TRANS/WP.29/2003/73
28 July 2003

**PROPOSAL FOR DRAFT SUPPLEMENT 4 TO THE 05 SERIES
OF AMENDMENTS TO REGULATION No. 83**

(Emissions of M₁ and N₁ categories of vehicles)

Transmitted by the Working Party on Pollution and Energy (GRPE)

"4.2. ..., the following procedure is used (see Figure 4/2 below).

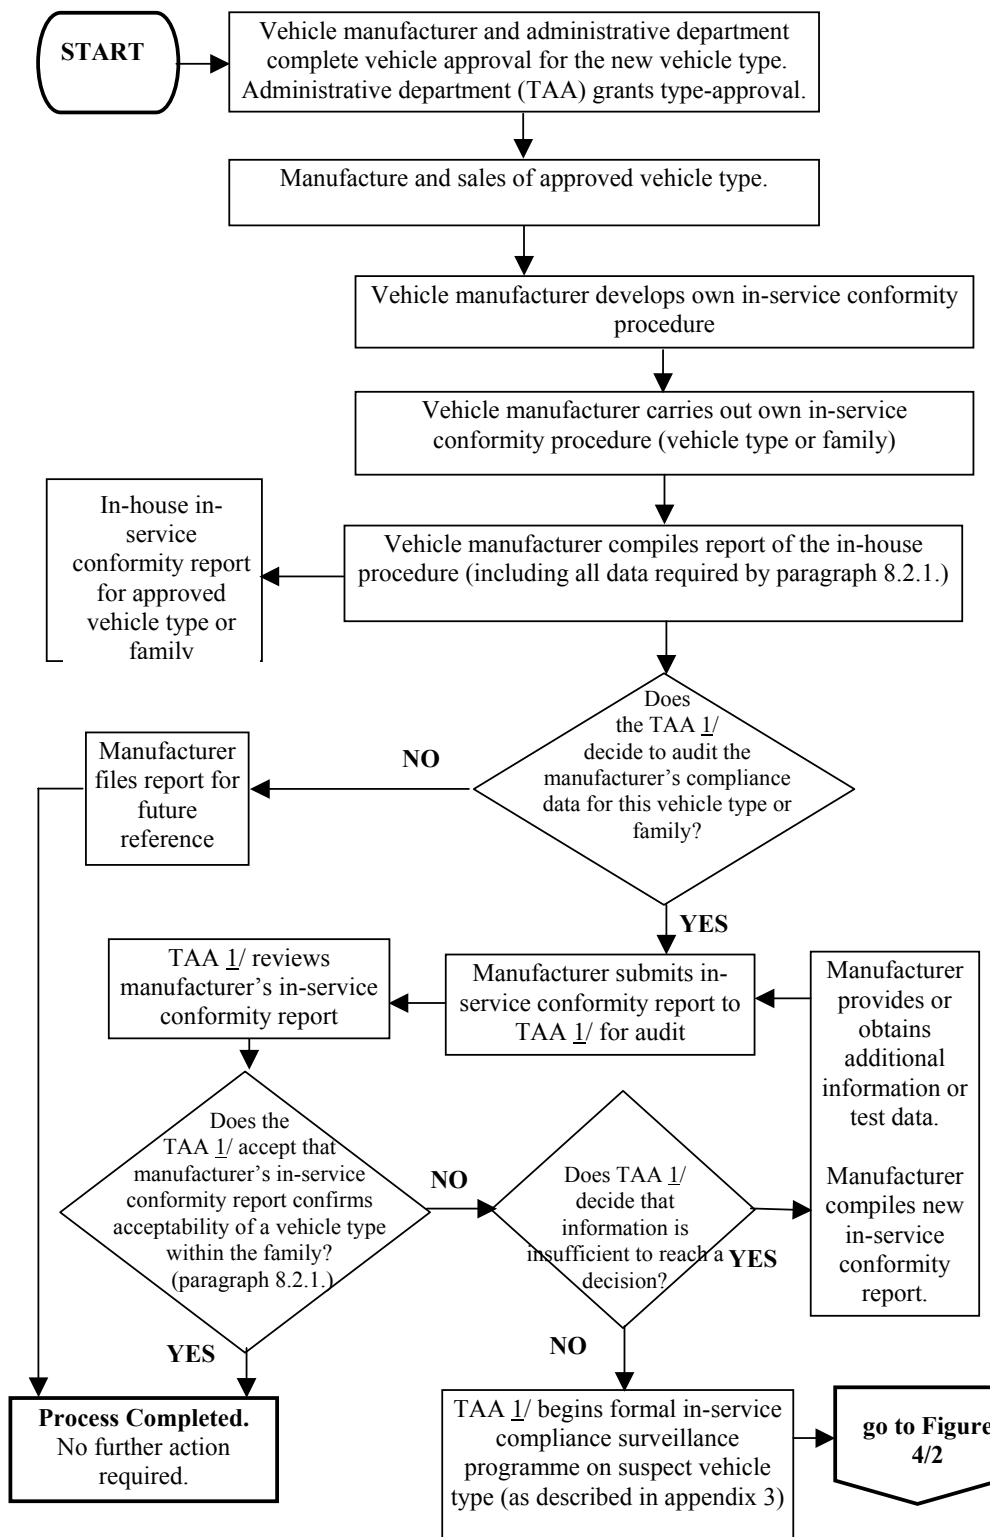
Paragraph 4.2., amend to read:

"Figure 4/2:

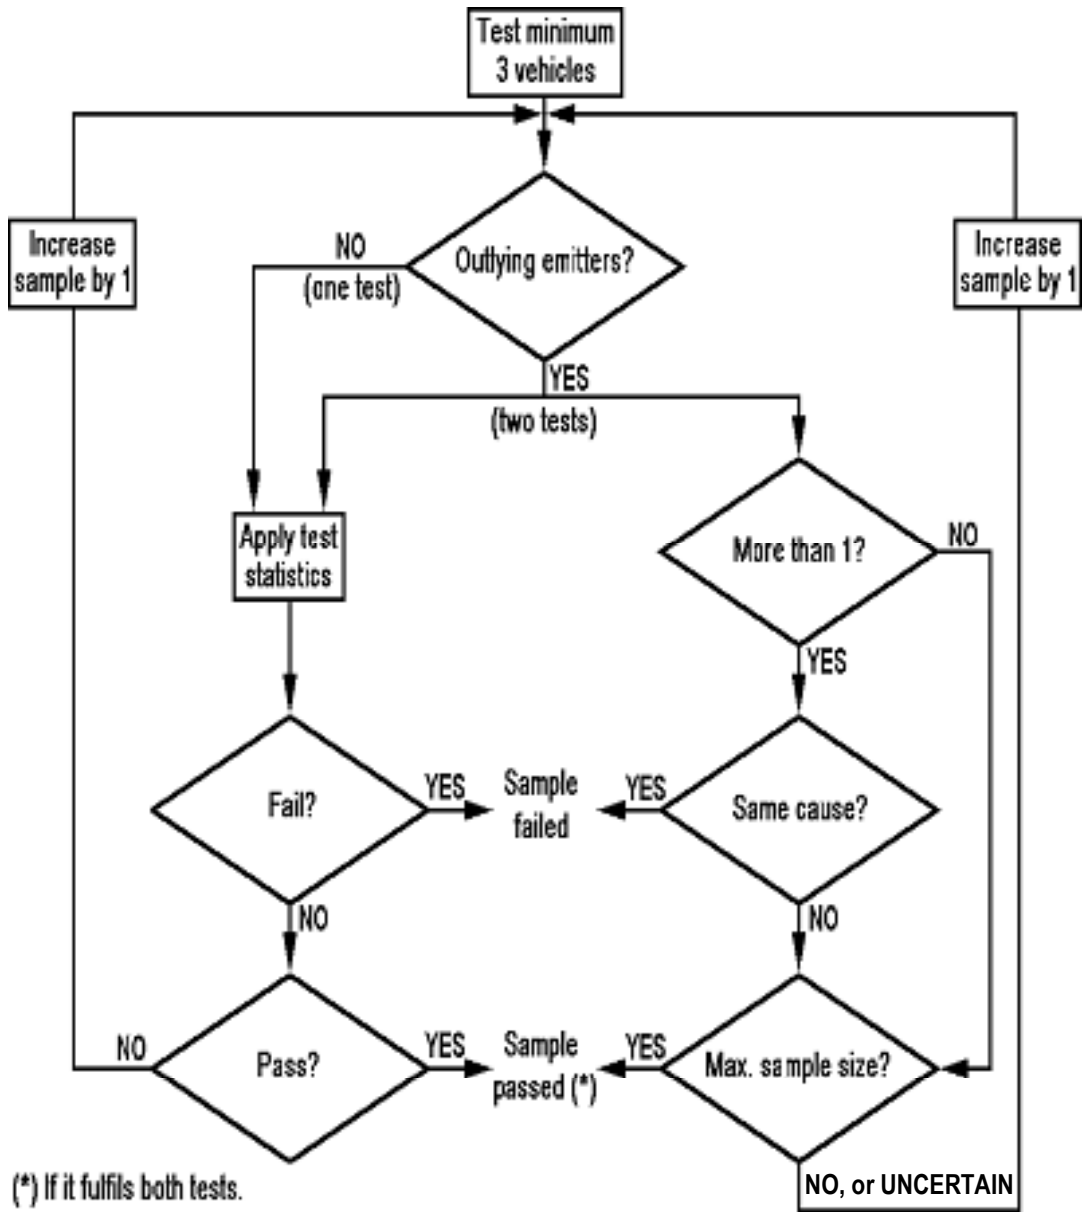
Figure 4/1 (former), rename as Figure 4/2 and amend to read:
